FA-Y-0013

### Notice of specification changes due to revision of UL standards for MELSEC iQ-R Series Energy Measuring Module

MELSEC iQ-R Series Energy Measuring Module

Example : Model EMU2-CT5

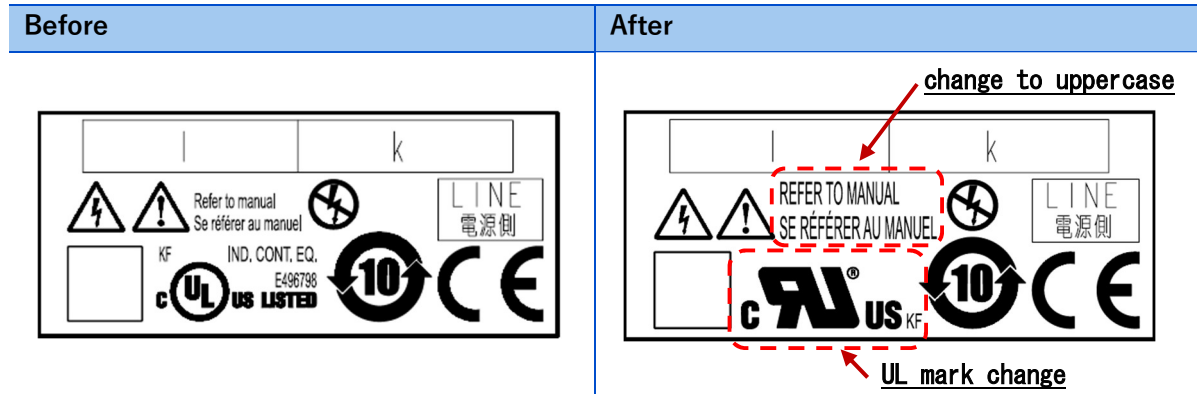
Due to the revision of UL standards, the labeling of Split-type current sensors will be changed. Please note that there are no changes to the product's general specifications, performance specifications, functions, external dimensions, etc. due to this change.
